**SUBJECT:** Generic Request for Order EA-03-009

**PROJECT NUMBER:** 689

**Supplement to MRP-95 Addressing Action Items from 10/09/03  
Teleconference with NRC**

**Peter C. Riccardella  
Structural Integrity Associates  
Oct. 10, 2003**

**Figure 1 – Expanded Plot of Hoop Stresses in Region below 13° Nozzle in Plant B Showing Semi-Elliptical Surface Flaw Assumption**

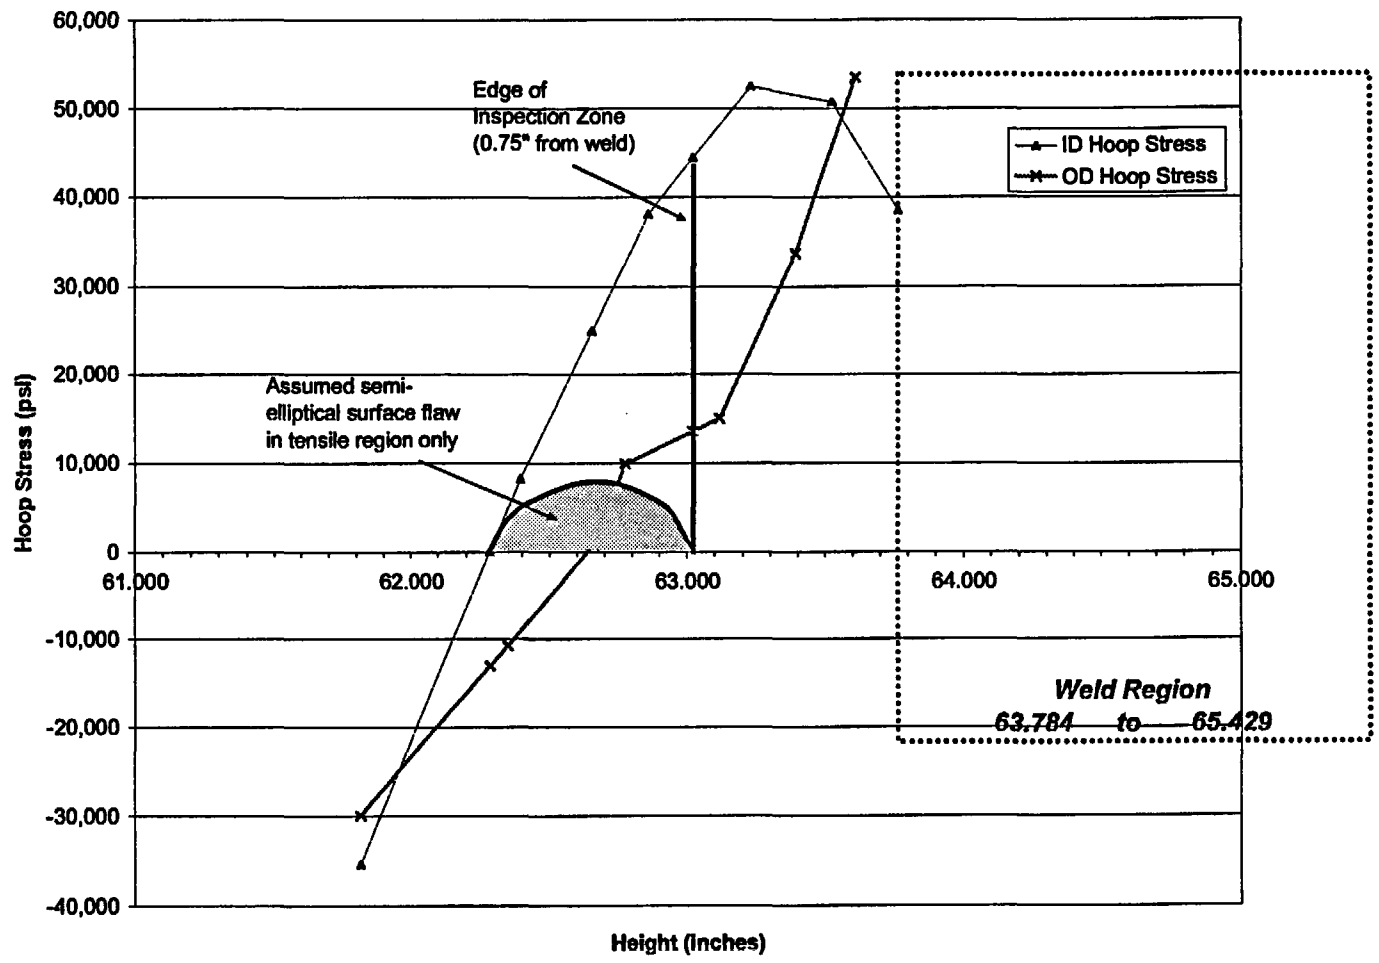
**4. Evaluation of semi-elliptical surface flaw in tensile region below weld of worst-case nozzle.**

A semi-elliptical, ID surface flaw was assumed to be present at the limiting, downhill location of the above-noted worst case nozzle (Plant B 13°). An expanded plot of the hoop stresses in that region is provided in the attached Figure 1. The assumed semi-elliptical surface flaw is also superimposed on that plot. The surface flaw was assumed to extend from the point at which the ID hoop stresses become positive to the edge of the inspection zone (0.75" below the weld). This results in a flaw length of 0.75" at the

surface. A flaw aspect ratio of 0.5 was assumed, which yields a maximum depth of 0.375", more than half the tube wall thickness. The mid-plane ID surface stresses were assumed to be acting on the flaw, which yields a K at the flaw tip impinging on the inspection zone of 22.0 ksi $\sqrt{\text{in}}$ , which is considerably less than the stress intensity factor reported in the revised Table 4.3 for a through-wall crack impinging on the inspection zone (36.6 ksi $\sqrt{\text{in}}$ ). Even if the stress at the edge of the inspection zone 44 ksi ID to 14 ksi OD is assumed to be acting over the entire flaw (a very conservative assumption), the resulting stress intensity factor is 36.1 ksi $\sqrt{\text{in}}$  which is still smaller than the through-wall crack value. Thus it is demonstrated that the through-wall crack assumptions used in MRP-95 (from the bottom of the tube to the edge of the inspection zone) conservatively bound the crack growth rates that would be predicted for smaller surface flaws in the tensile region, for the worst case nozzle and flaw location.
